FIELD SAFETY NOTICE / PRODUCT NOTIFICATION

Subject:	Brainlab Ultrasound Navigation Software: Changing the image width for a probe in the BK Medical Ultrasound System during surgery can add a deviation to the intraoperative ultrasound image displayed by the Brainlab navigation.
Product Reference:	Ultrasound Navigation Software 1.0.x Ultrasound Integration Software for Cranial/ENT Navigation 3.0.x and 3.1.x
Date of Notification:	August 31, 2020
Individual Notifying:	Markus Hofmann, Senior Vigilance Manager
Brainlab Identifier:	CAPA-20200825-002368
Type of action:	Advice regarding use of device; Device modification

Figure 1: Illustration of the potential added vertical deviation to the intraoperative ultrasound navigation overlay display from a non-linear probe.

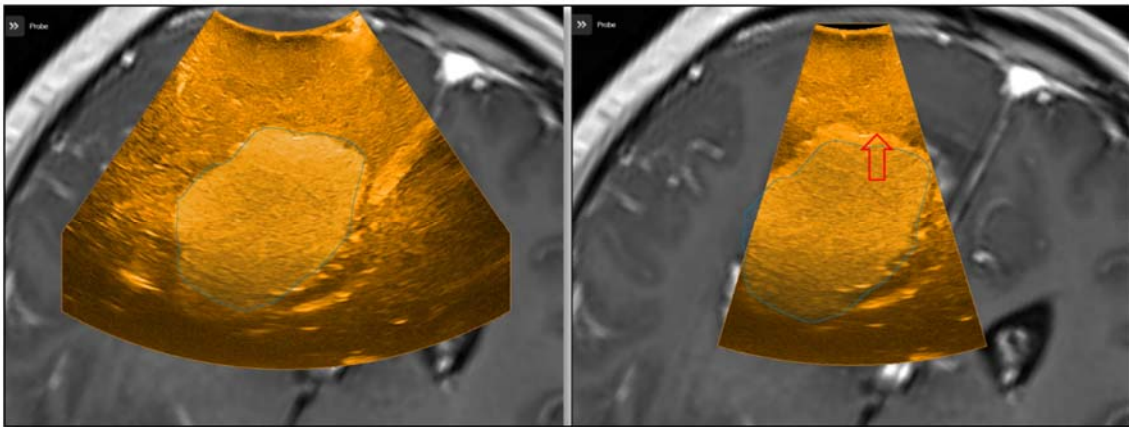
If the added deviation occurs, it becomes visible in the depth of the probe's image in the direction of the ultrasound probe axis, as illustrated below.

Left: Width = 100%; calibrated (default) value was used for navigation: the blue tumor object outlined in the navigation correctly coincides at the same height with the hyperechoic tumor (brighter portion).

Right: Width = 50%; image width was changed from its calibrated value during navigation: the hyperechoic tumor (brighter portion) in the ultrasound image appears incorrectly shifted higher compared to its actual location in the MR scan.

1. The Ultrasound Navigation Software does not support changing the image width of a non-linear BK Medical probe; therefore, **do not change this width value in the ultrasound system during a surgery, to avoid an incorrect overlay visualization in the navigation.** Keep the same (default) value as when the probe was calibrated to navigation.
